***Application for Amendment of USNRC Source Materials License
SUA-1601, Ross ISR Project, for the
Kendrick Expansion Area***

***RAI Question and Answer Responses for the
Kendrick Expansion Area Environmental Report
Docket #40-09091***

Prepared by:
Strata Energy, Inc.
1900 W. Warlow Drive, Bldg. A
P.O. Box 2318
Gillette, WY 82717-2318

August 2016

Drill Holes on 2012 NAIP Aerial Photography

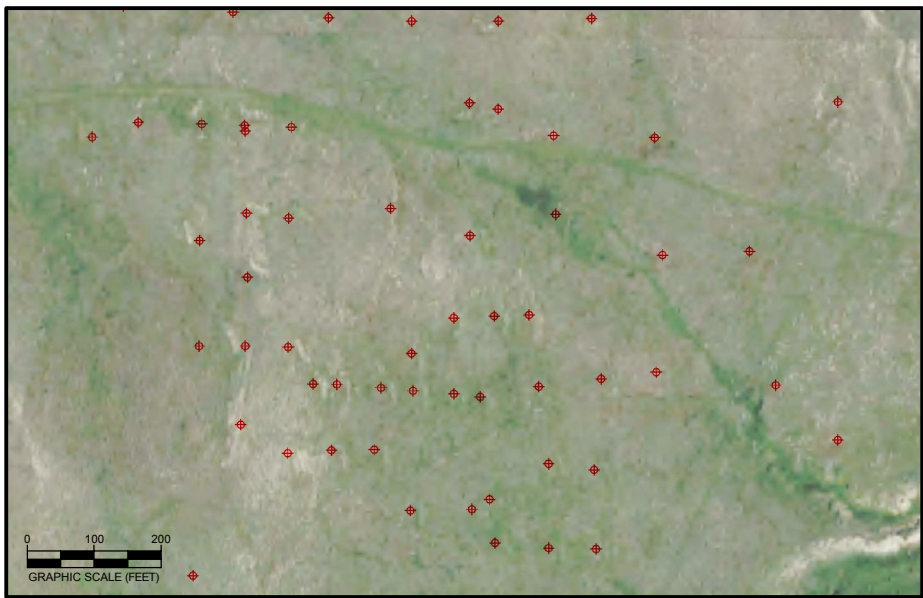
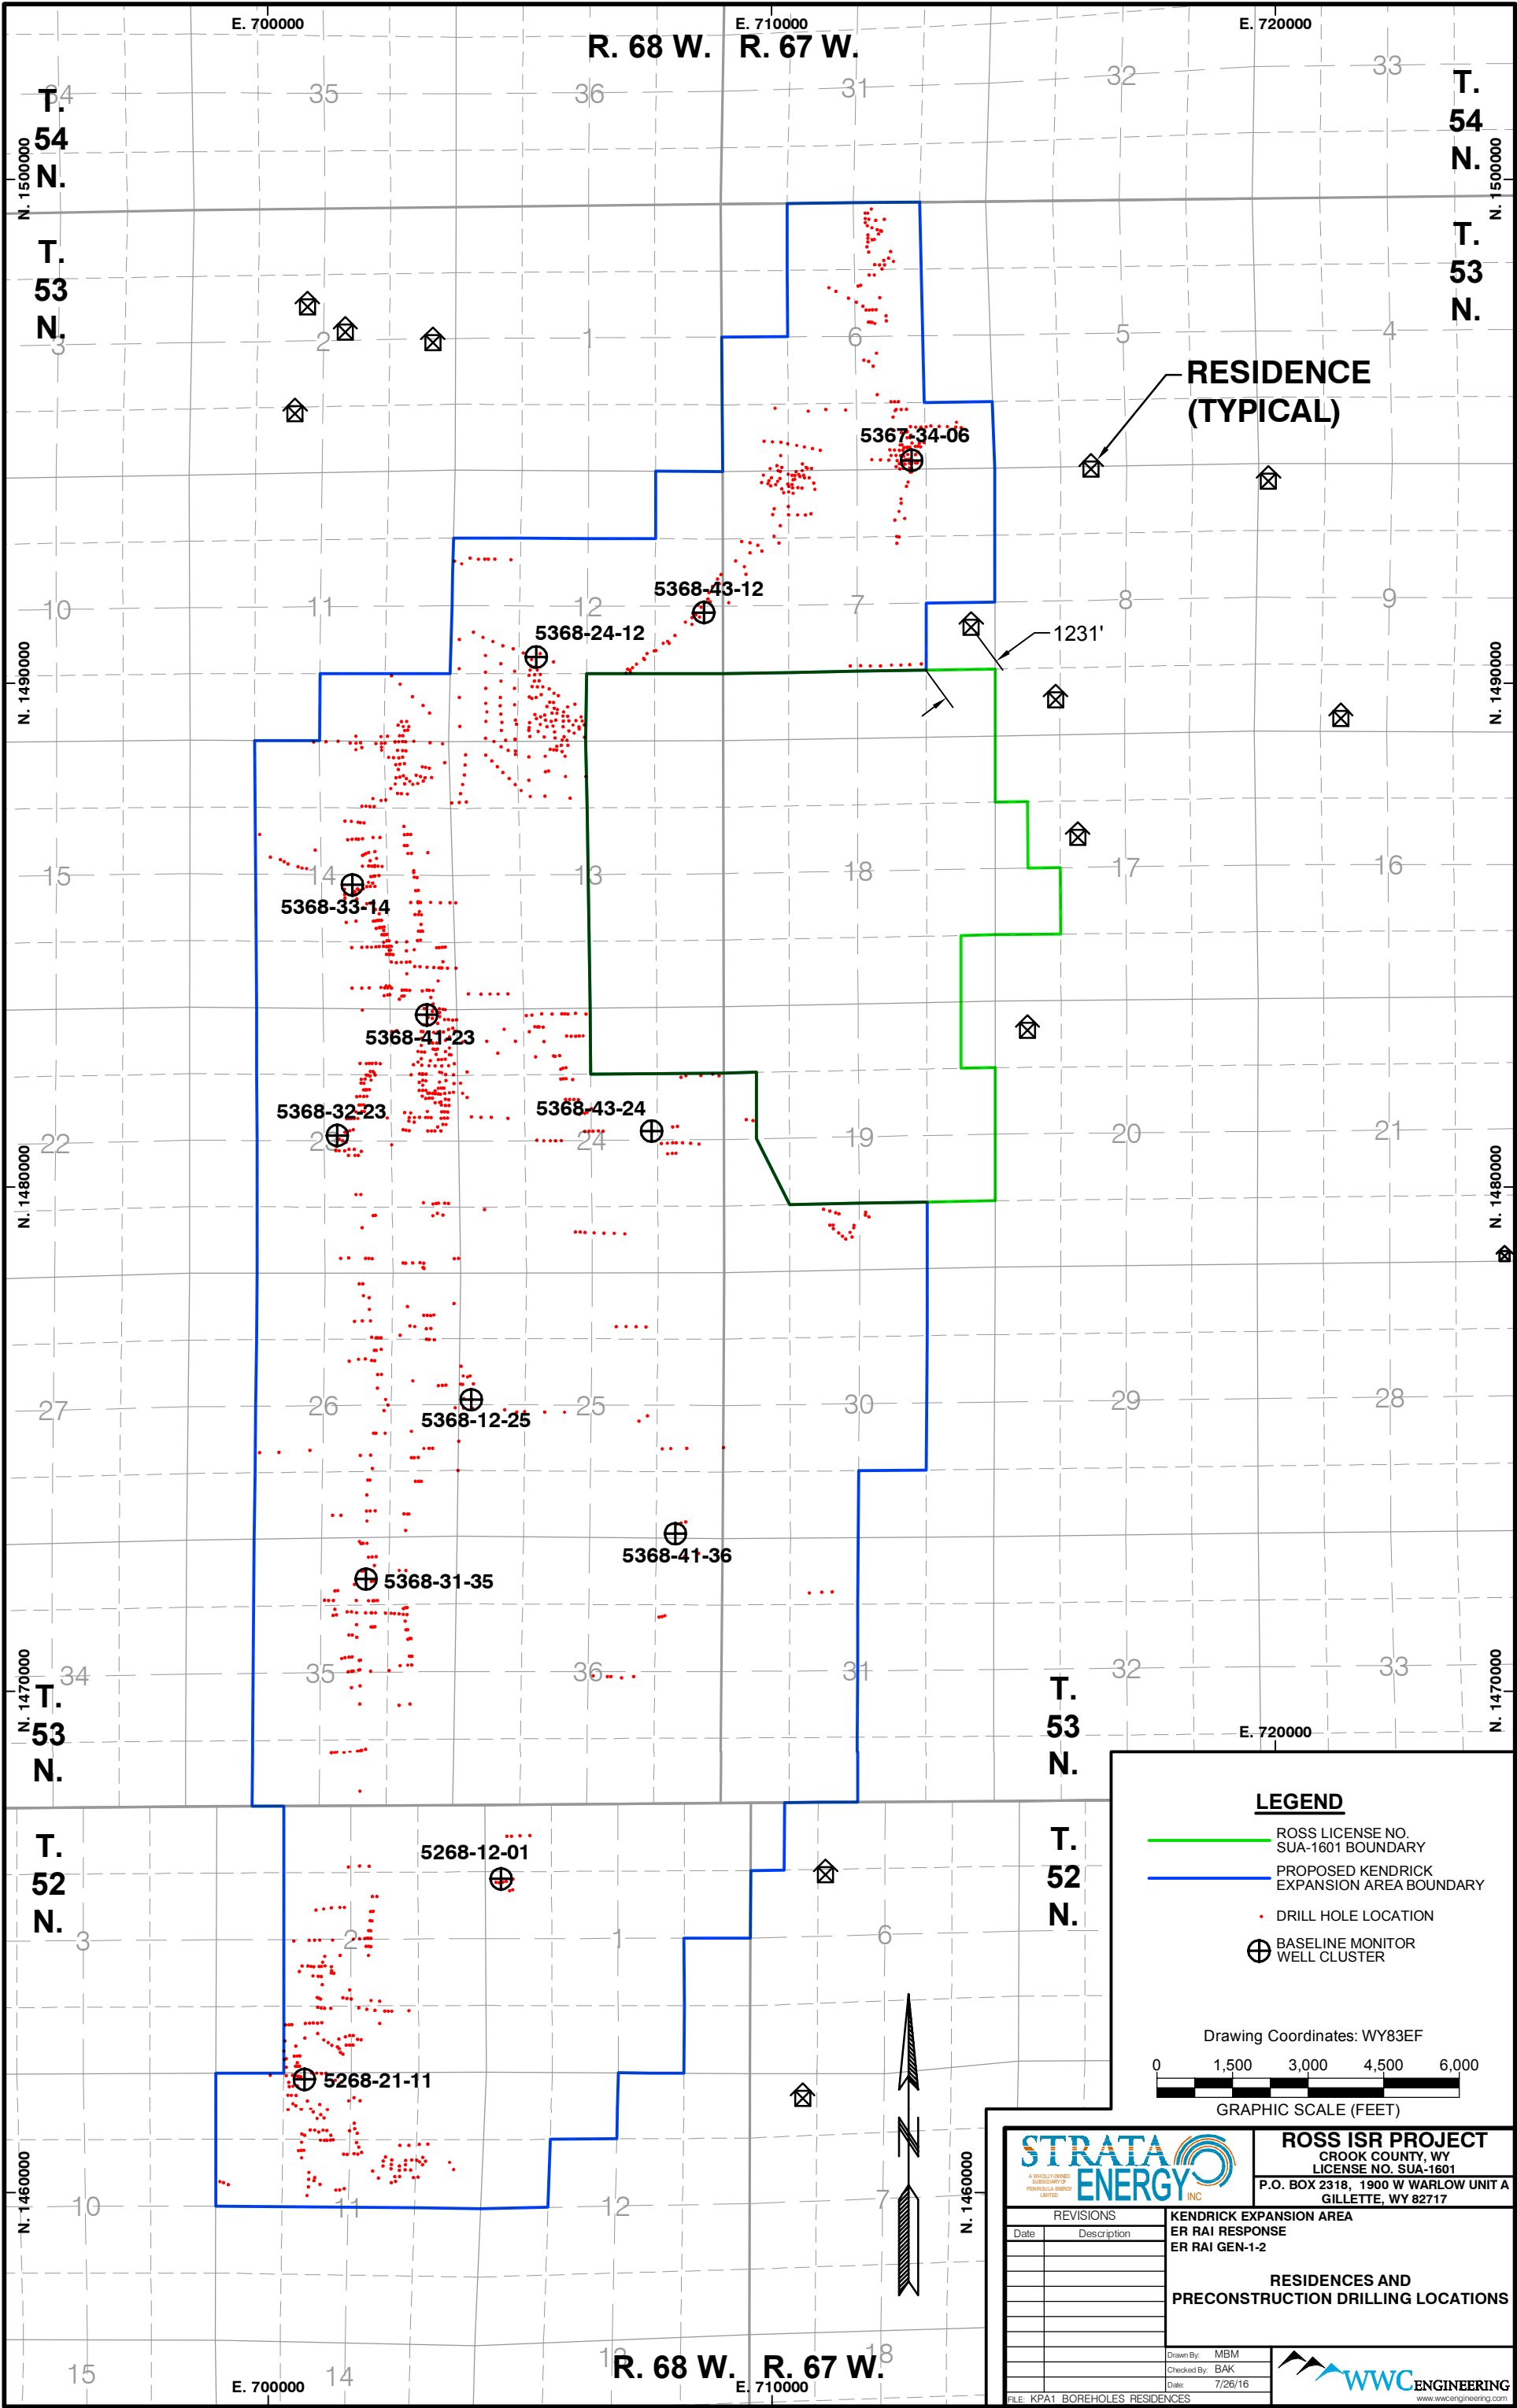
- A. *Clarify the description of those Kendrick site preparation (or preconstruction) activities excluded from the definition of construction (i.e., a description separate from that of the description of the proposed construction activities) that have been or will be undertaken, regardless of when those activities may occur in relation to the potential issuance by the NRC of the amendment to the license to construct and operate the proposed ISR facility.*

Most preconstruction drilling activities have taken place well inside the proposed KEA boundary, and the noise levels from drilling activities have seldom exceeded the annoyance noise threshold of 55 dBA. Figure ER RAI GEN-1-2 shows the drill holes and regional baseline monitor wells completed by Strata within the proposed KEA. The nearest drill hole to a residence is 1,231 feet away, which is estimated to have resulted in a drill rig noise level of 24-46 dBA, based on the equation in Kendrick ER Section 4.7.1.1.1. Recognizing that backhoes and other equipment could result in higher short-term noise levels at the drill site, as described in the response to ER RAI NOI-1, the maximum noise level at the nearest residence resulting from drilling activities at the nearest drill site may have been above the annoyance noise threshold. However, this equipment would not have operated for more than a short duration, and only a few of the preconstruction drill holes were within even half a mile of a residence. Future preconstruction activities would likely be confined to areas along the ore trends that have been delineated previously and would be expected to result in similarly small potential noise impacts. Consistent with Kendrick ER Section 2.3.4.8, the preconstruction activities would have a small potential noise impact that would not generally overlap with the Proposed Action. Preconstruction activities also would have a small cumulative impact when added to the small cumulative noise impacts from other past, present, and RFFAs, since noise would be localized and short term.

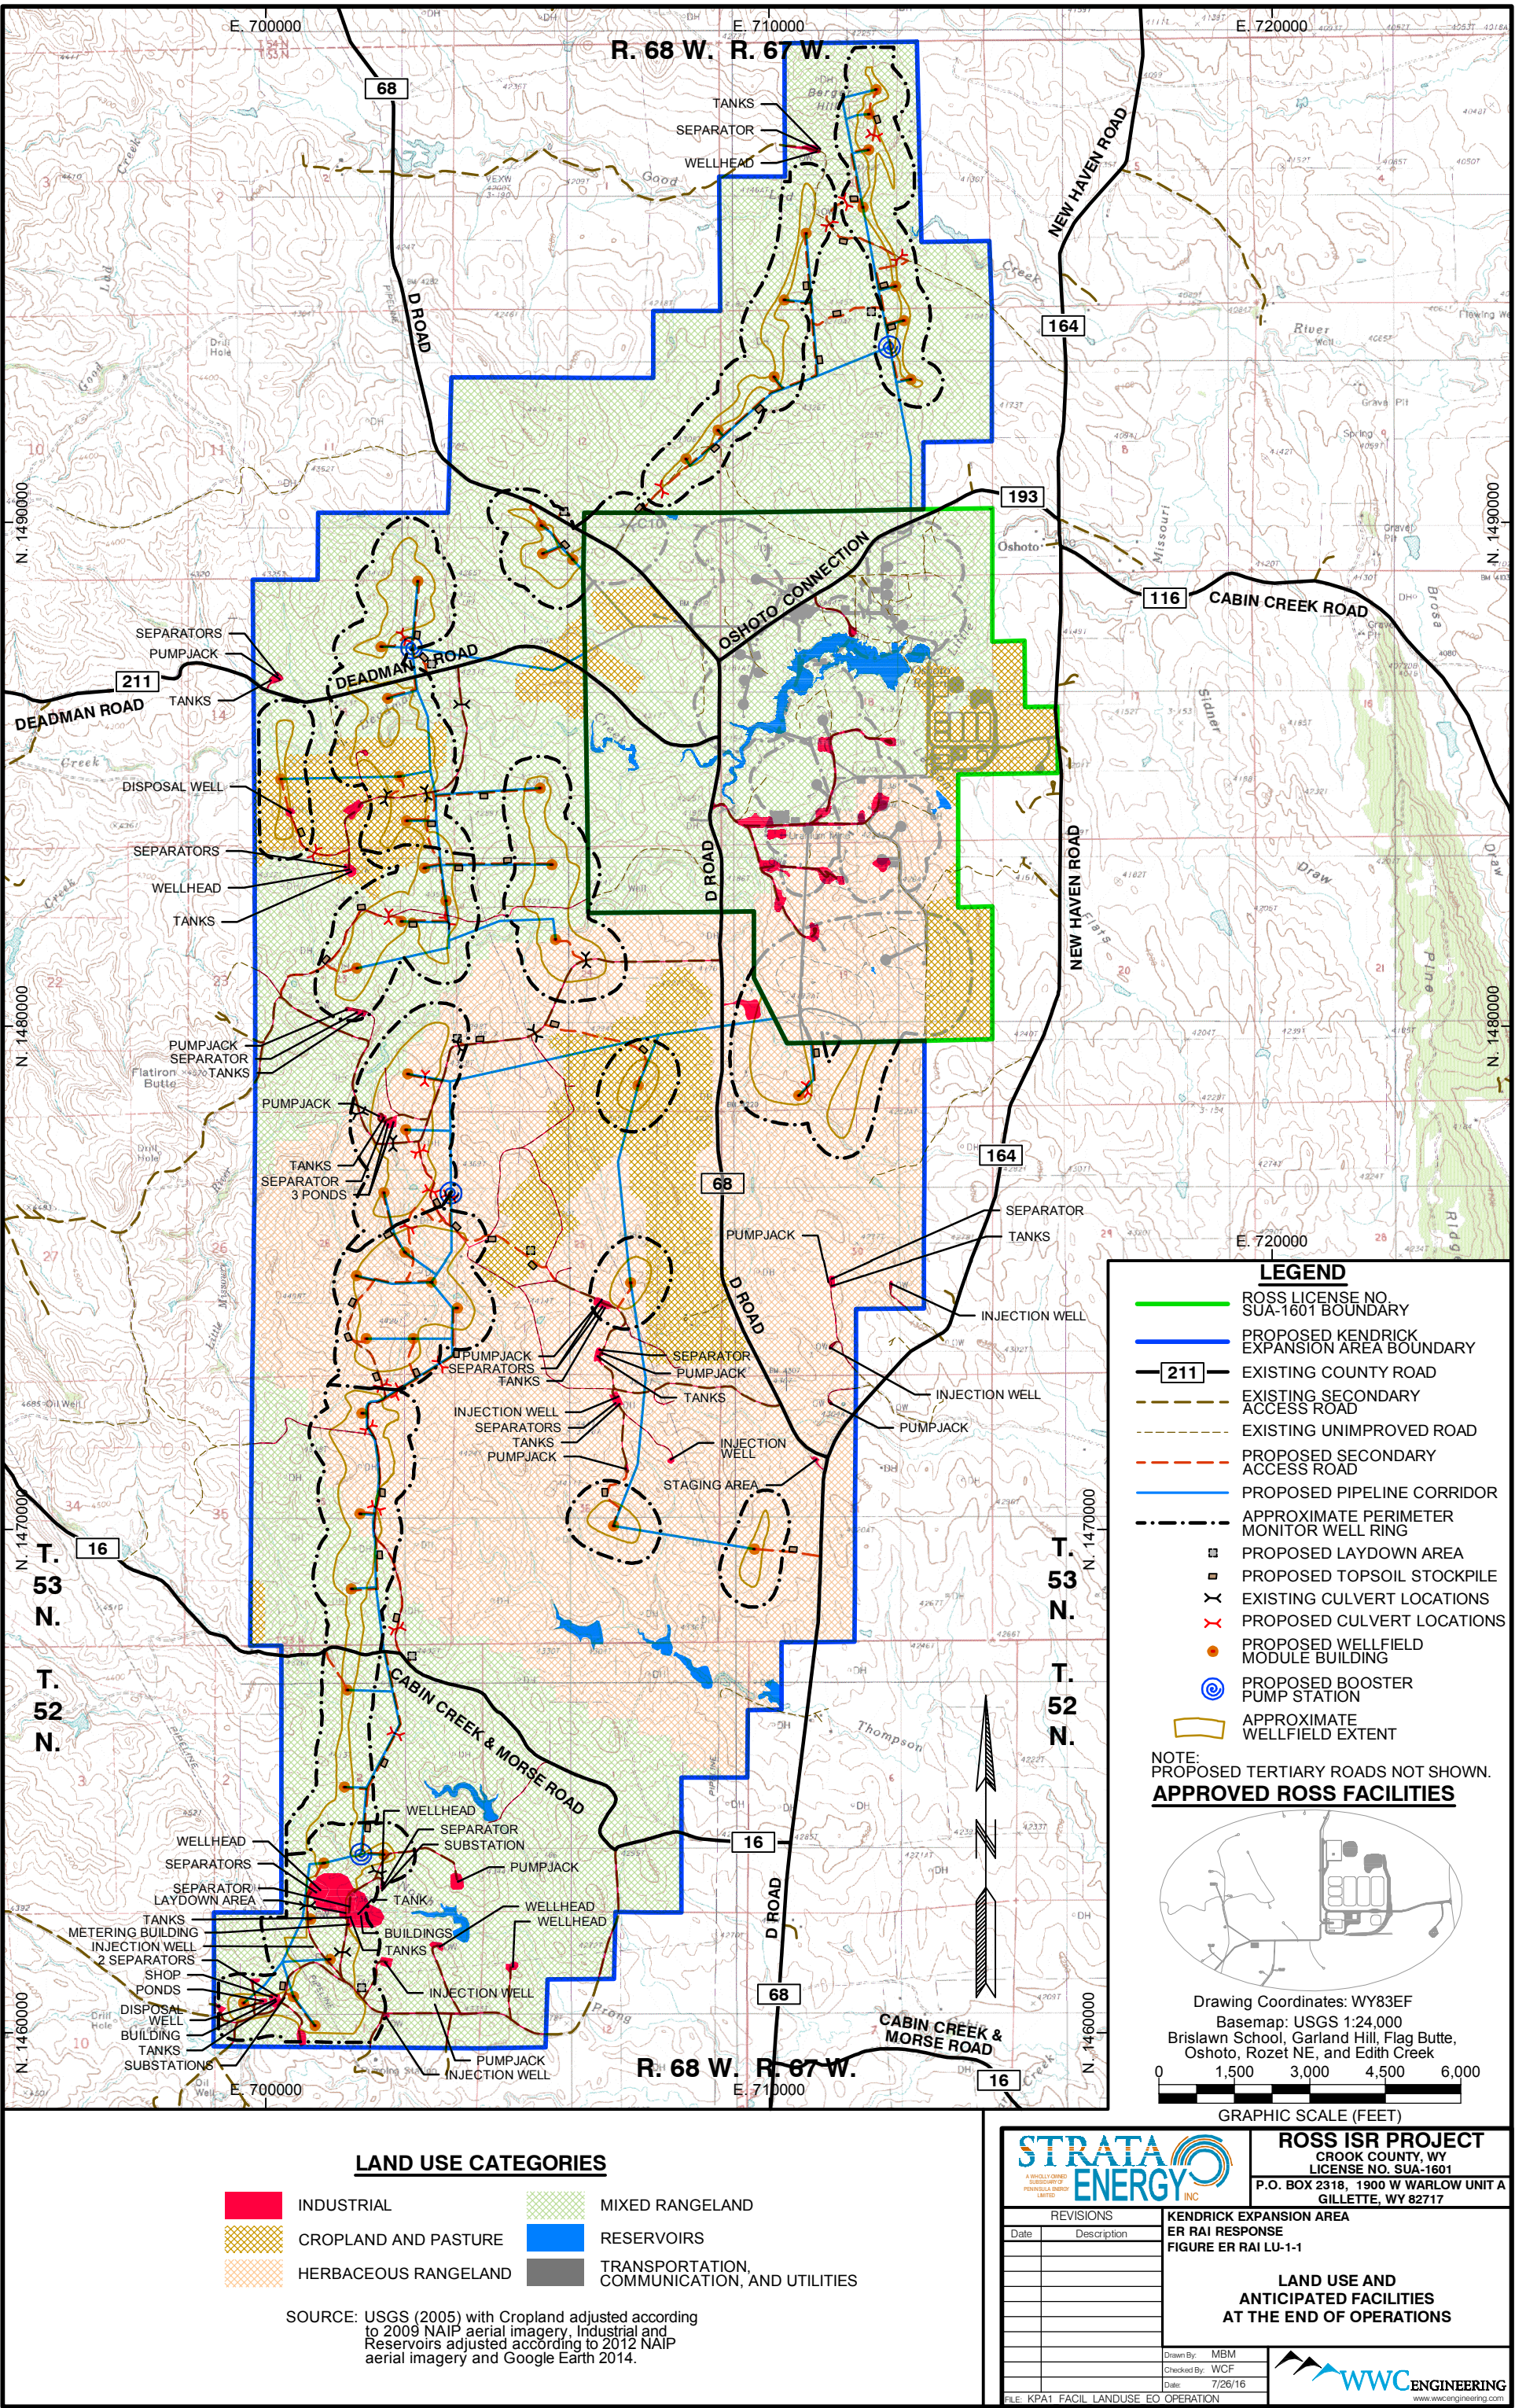
In its responses to the RAIs for Ross, Strata provided Figure ER RAI GEN-1-1, which overlays the proposed activities for Ross over a map of the license area that also shows the land use categories. Provide a similar figure for Kendrick, showing the facilities present at the end of the construction phase overlaying the land use categories for the site (i.e., combine Figures 4.1-2 and 3.1-3). Alternatively, provide the native CAD or shapefiles/layers so that the NRC staff can develop the figures.

Figure ER RAI LU-1-1 portrays the land use categories from Kendrick ER Figure 3.1-3 along with the anticipated facilities at the end of operations from Kendrick ER Figure 4.1-2. A native CAD (AutoCAD) file for Figure ER RAI LU-1-1 is provided with the response to ER RAI GEN-8.
